Multiple Award construction Contract (MACC) II

NNA12450885R-PFM

Questions and Answers-Set 5

April 11, 2013

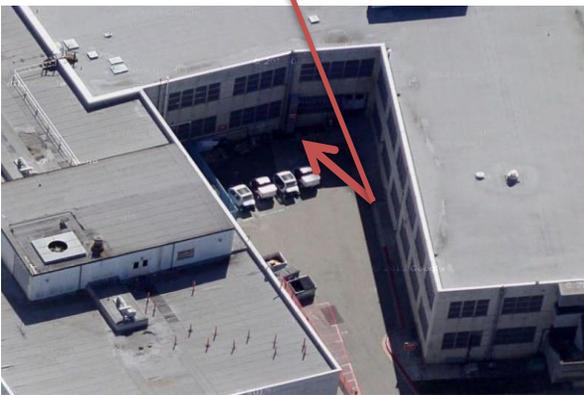
Q61. Will we be permitted to utilize the elevator located inside of building for N213 east and west to remove and bring in the new equipment?

A61. For the Sample Task Order, the elevators located in building N213 are not for equipment delivery. There are two openings in the back of N213 (see pictures below) for equipment delivery.

Here is one opening of N213, outside back door.

Here is another opening in the back of N213. Opening is by the long ramp.
